Technical Note

Project No: ITB16357
Project Title: Land South of A259, Angmering
Title: Additional Information – A/168/21
Ref: DS/ITB16357-008
Date: 11 October 2021

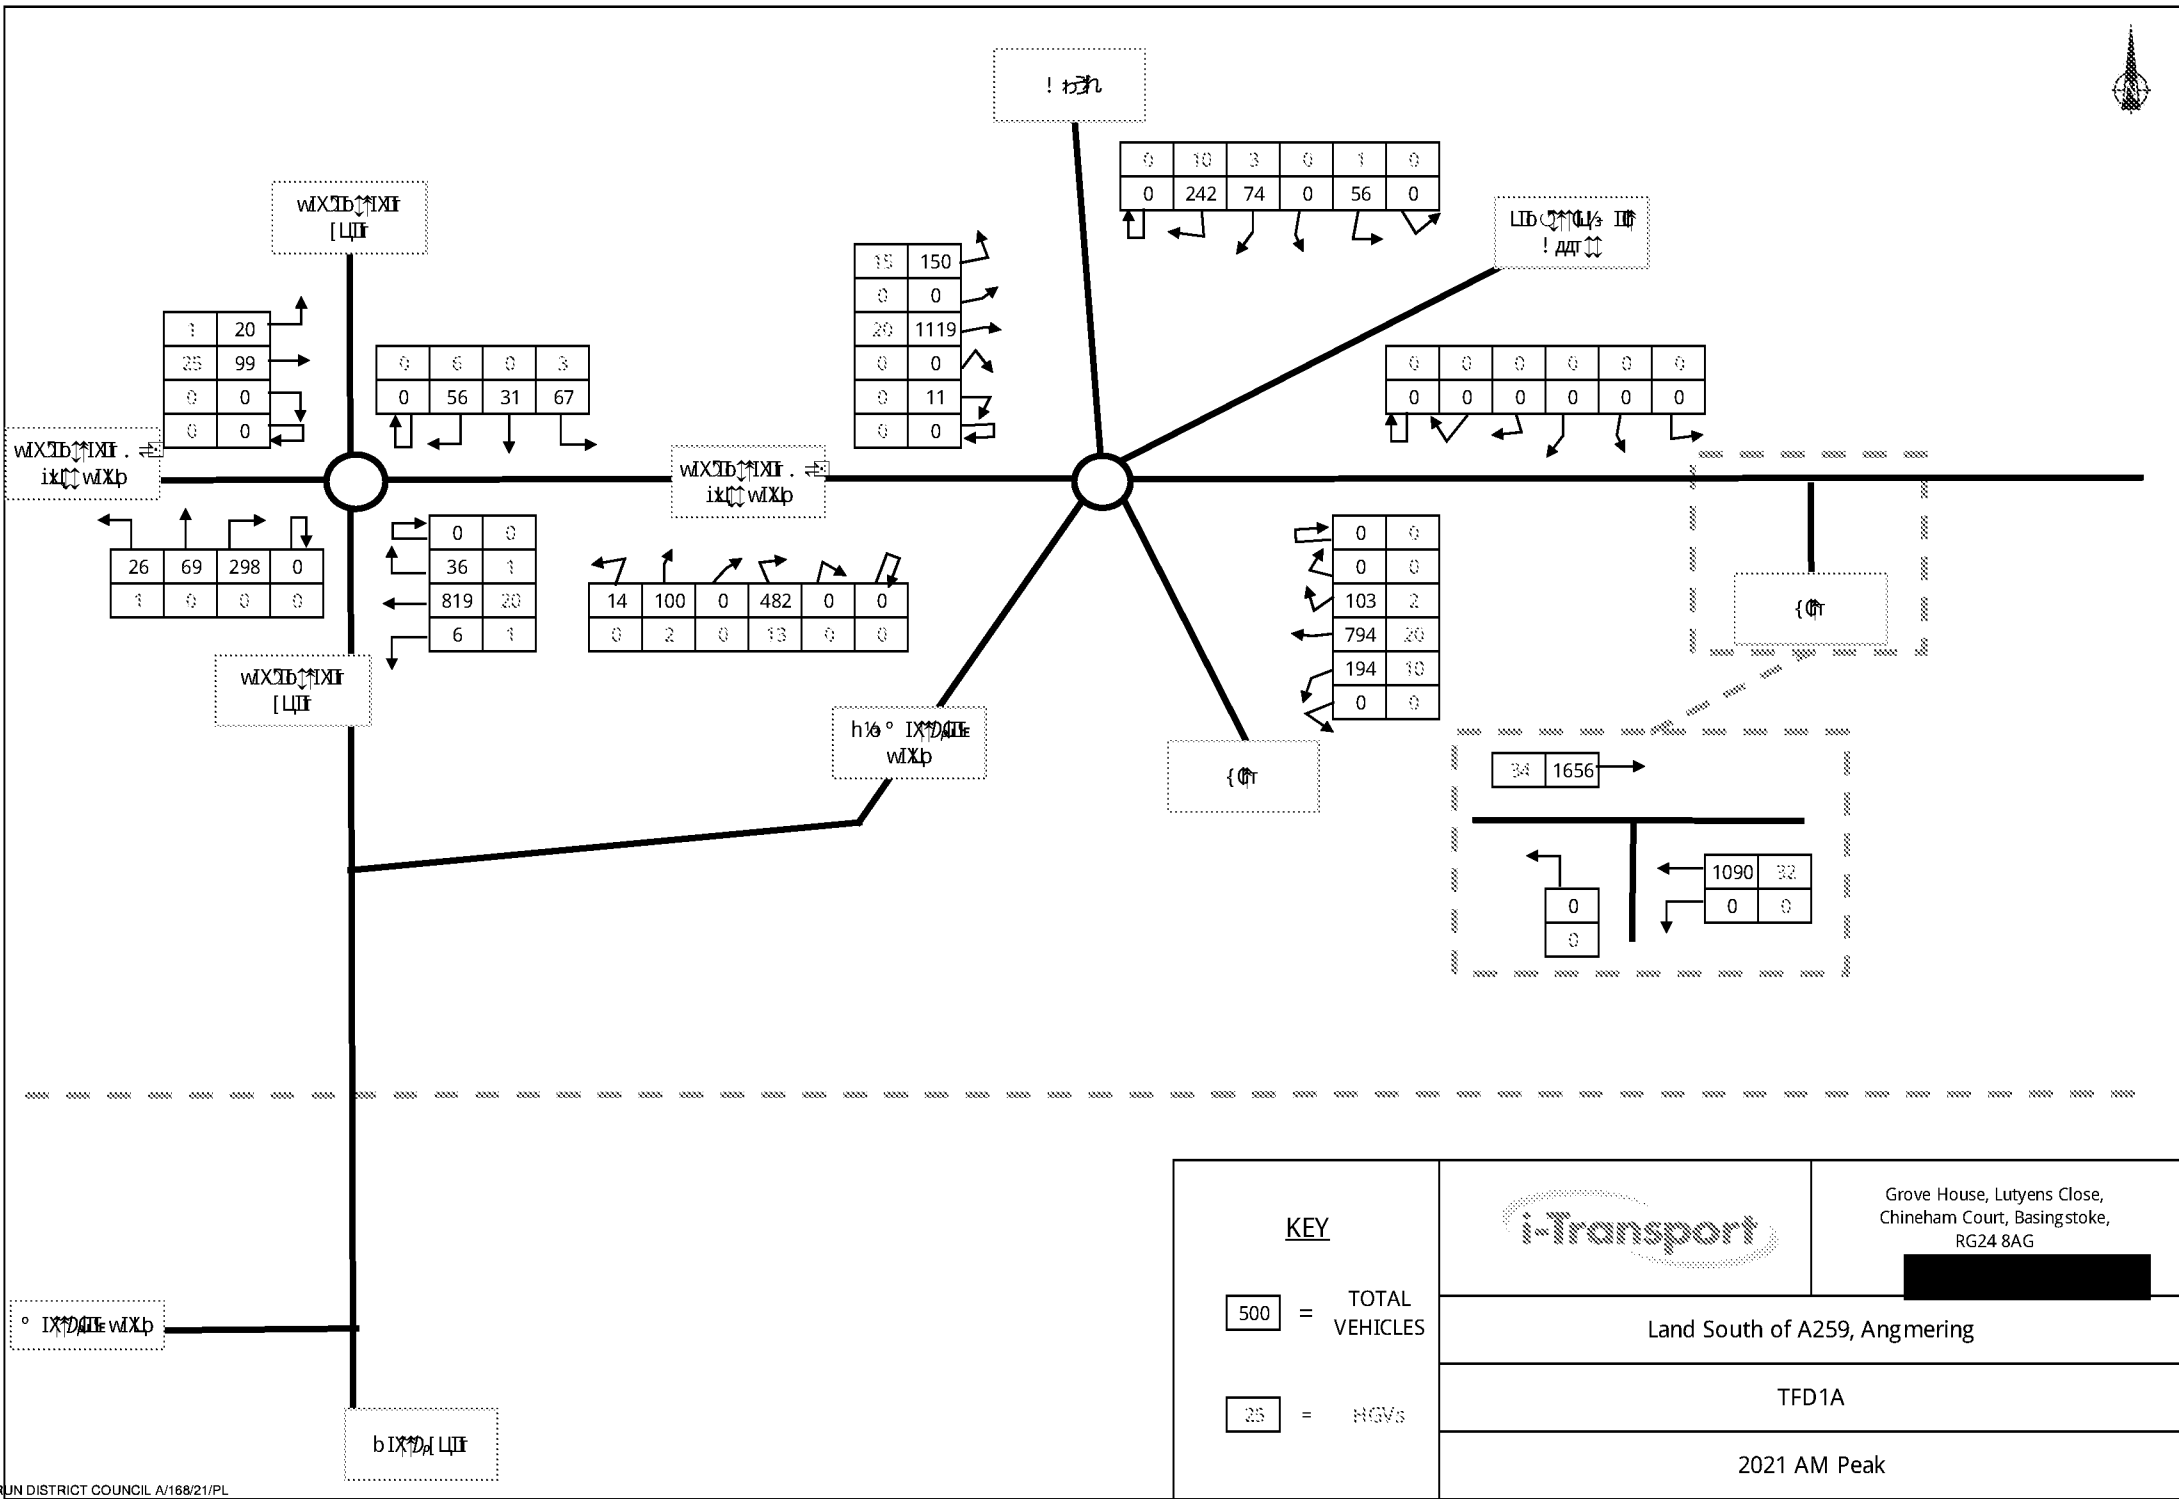
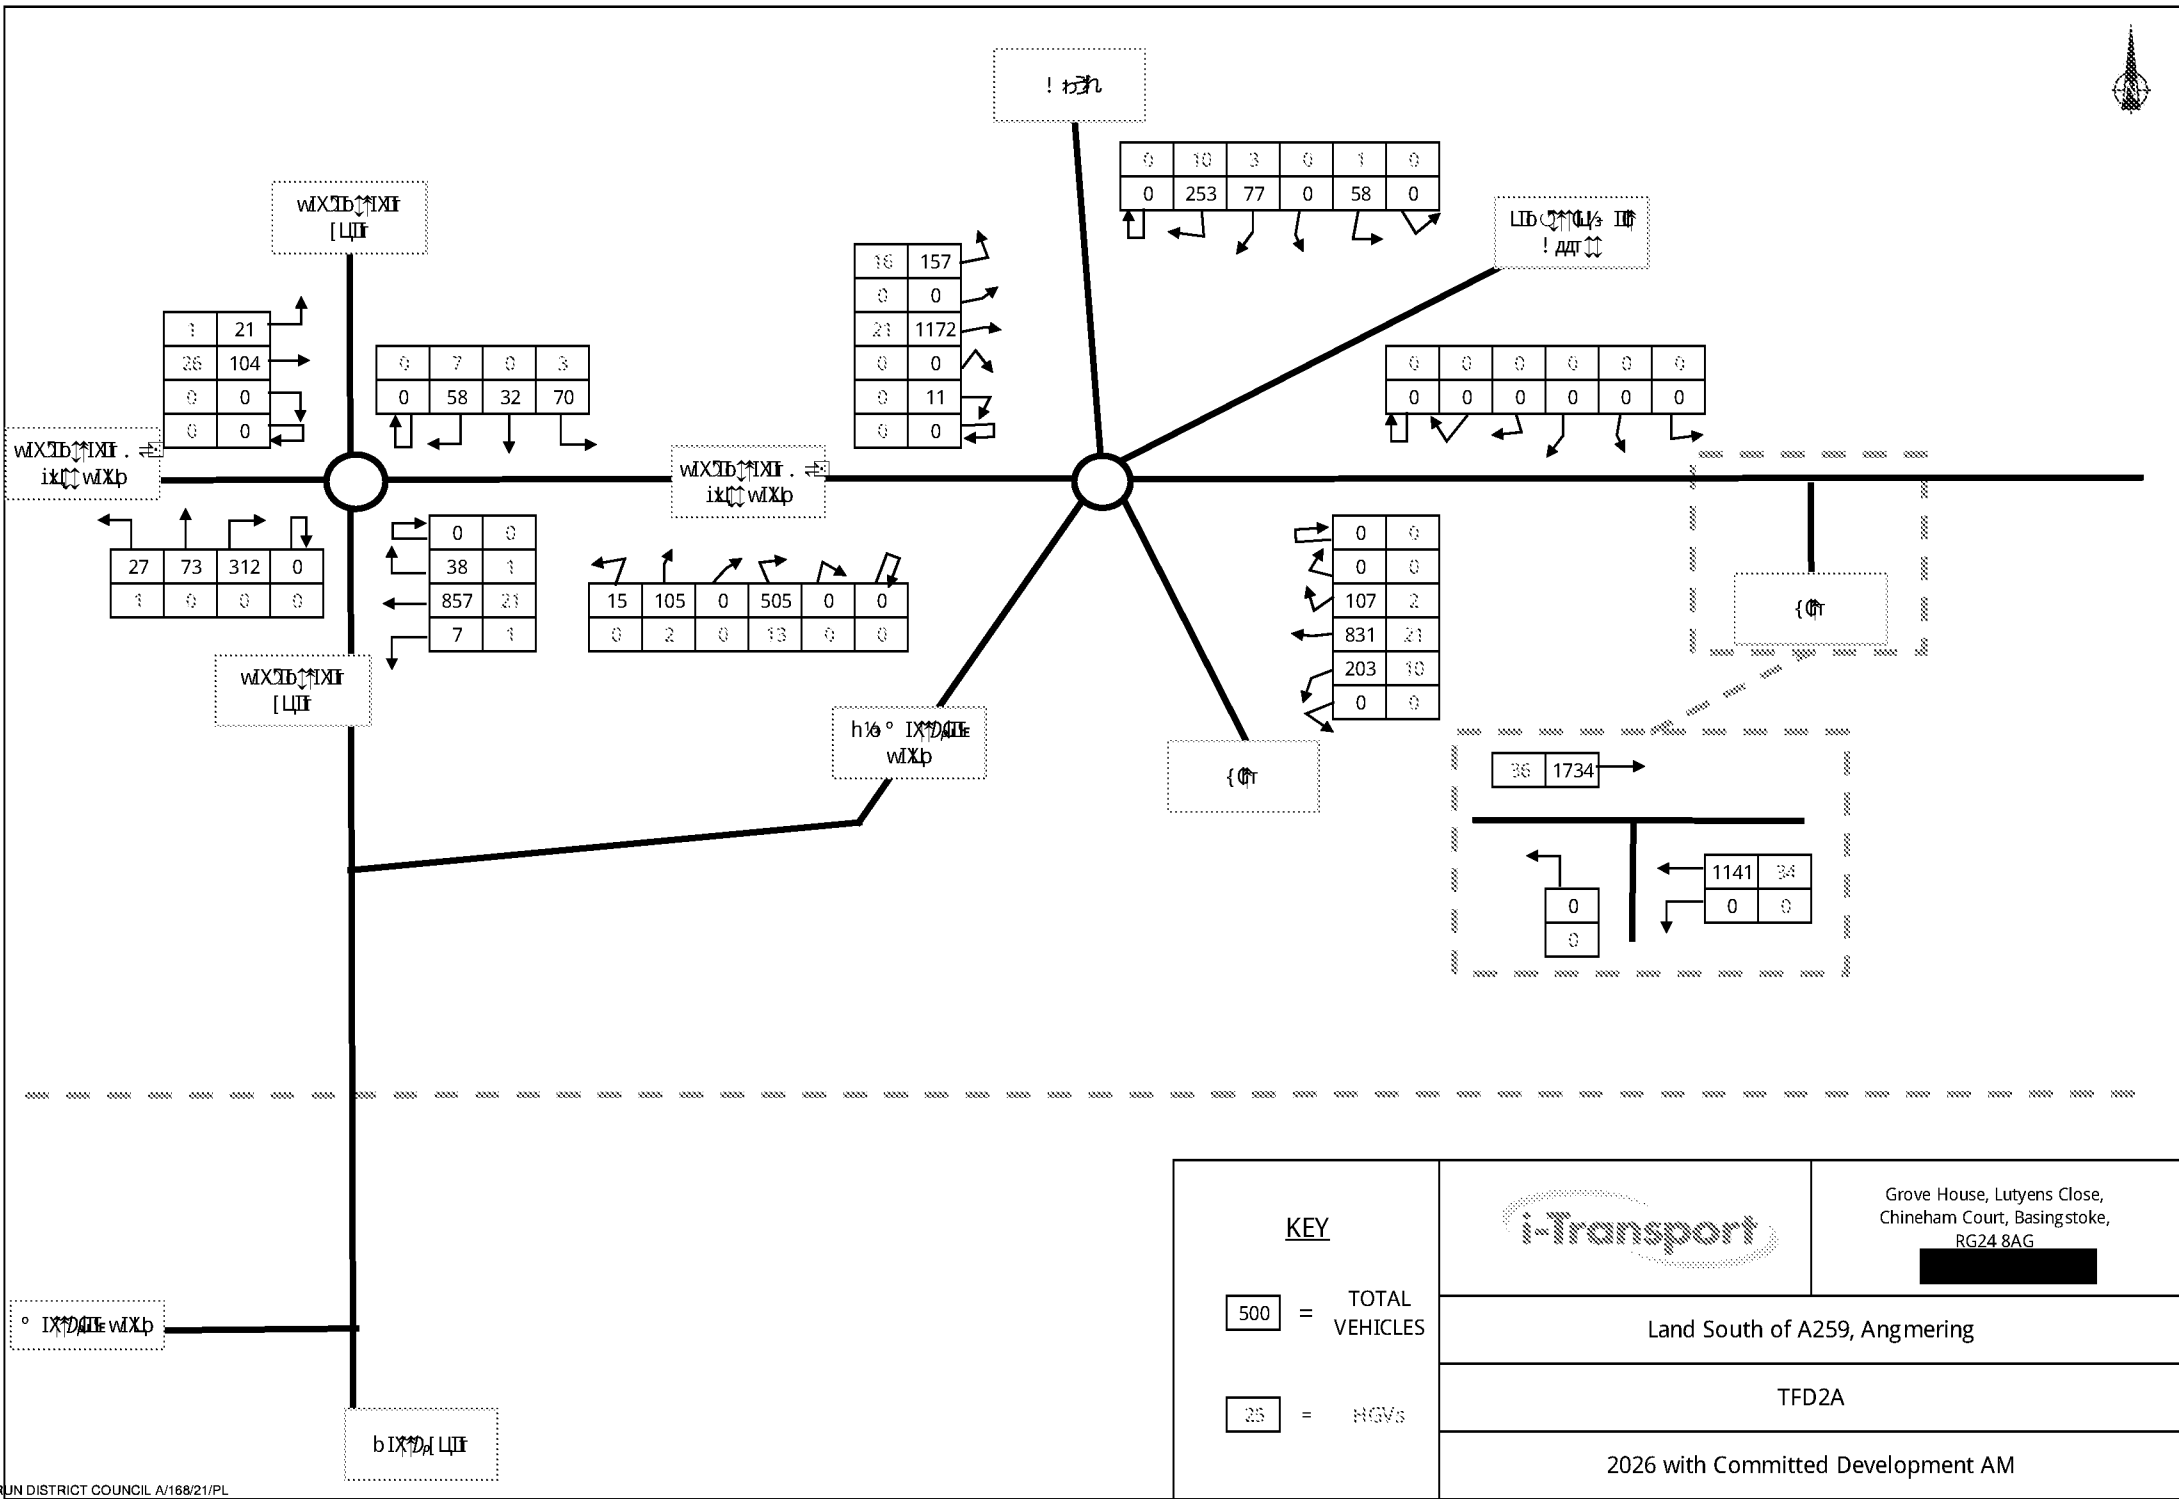
- 2.2 The design of the site access arrangement has been modified in order to remove the existing bus stop located on the live nearside lane of the A259 carriageway, as requested in the WSCC response. The amendment is shown in **Drawing ITB16357-GA-003 Rev E**.

- 3.1.9 Notwithstanding, the Applicant is willing to deliver some improvement of the cycle route that can be incorporated into, and constructed alongside, the site access works. A scheme of widening has been identified extending from the A259/A280/B2140 roundabout to the eastern boundary of the blue line plan. This includes the area in the vicinity of the TPO trees which will allow for hand dug construction techniques to be used, and the scope of the works in this area defined through the Section 278 Agreement. The works have been incorporated into **Drawing ITB16357-GA-003 Rev E**.
